BULLETIN NO. 100108

PRODUCT: Dunkirk PWXL Boilers

TITLE: Transformer Replacement

PHOTO 1

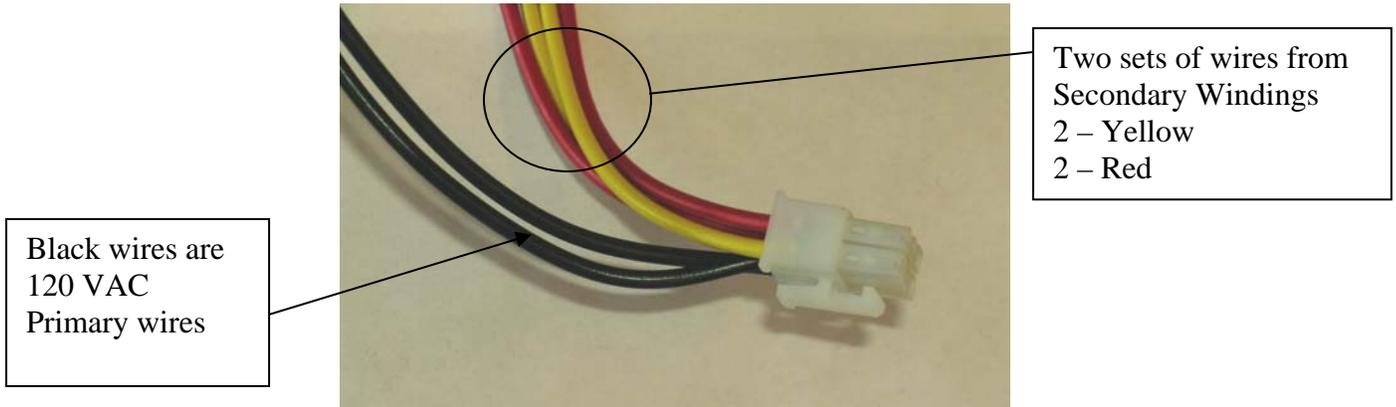
Replacement of Factory-Installed Transformer requires the use of OEM Parts Only! This is not a standard transformer. It has two sets of secondary windings. It is made particularly for the Hydrolevel control and has two sets of secondary transformer leads. Replacement using any standard transformers will result in Hydrolevel Aquastat control failure. See photos 1 and 2.

Dunkirk highly recommends wholesalers stock the following replacement parts.

| Part Number | Description | Where Used |
|--------------------|--------------------------------------|-----------------------------|
| 240007897 | Transformer | Used in all sizes. |
